ASB-1000

Service Bulletin

Subject: TS-850S Distorted TX w/TNC Connected **Date:** October 10,

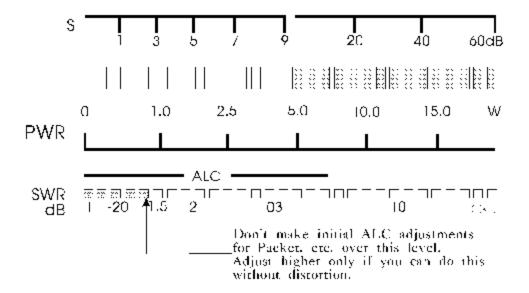
- Add a 10 db attenuator to the PKD line on the IF unit (X48-3080-XX). This will
 prevent overmodulation of the microphone input circuit.
 a.Change chip resistor R258 from 2.2K to 1K ohms (RK73FB2A102J)
 - b.Change chip resistor R260 from 220 to 330 ohms (RK73FB2A331J).
- 2. Add the following note to page 29 of the Instruction manual.
- 3. When adjusting for proper ALC levels with an AFSK RTTY terminal or Packet TNC terminal you should adjust VR-18 on the IF Unit for a reading similar to the one shown in the accompanying diagram.
